Product Change Notice (PCN)

PCN Number: PCN-0456174R-01

Product(s) Affected: PJ-040D

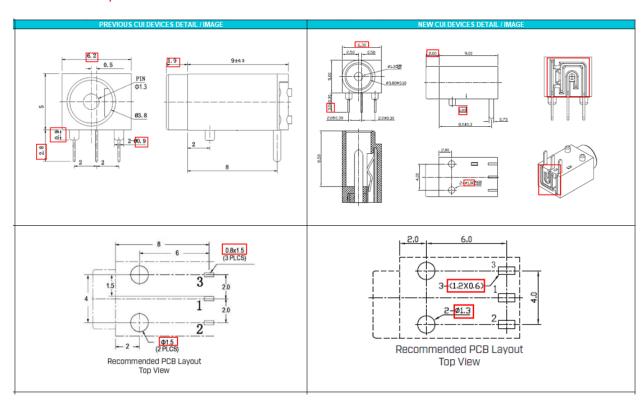
Description of Change: New Factory Location. Product re-engineered for improved manufacturability and production yield. See image below for reference and check CUI Devices website for updated drawing. Cosmetic differences may be visible and not affect the form fit and function of the product.

PREVIOUS CUI DEVICES DETAIL / IMAGE			NEW CUI DEVICES DETAIL / IMAGE		
DESCRIPTION	MATERIAL	PLATING/COLOR	DESCRIPTION	MATERIAL	PLATING/COLOR
center pin	brass	silver	center pin	brass	silver
terminal 1	brass t=0.25	silver	terminal 1	brass t=0.25	silver
terminal 2	brass :=0.25	silver	terminal 2	SUS301 t=0.25	silver
terminal 3	brass t=0.25	silver	terminal 3	brass t=0.25	silver
cover	PBT (UL94V-0)	black	housing	PA66 UL94V-0)	black
housing	PBT (UL94V-0)	black			
Ø3.5 MATING PLUG Jack Insertion Depth: B.0 mm			MATING PLUG Jack Insertion Depth. B.5 mm
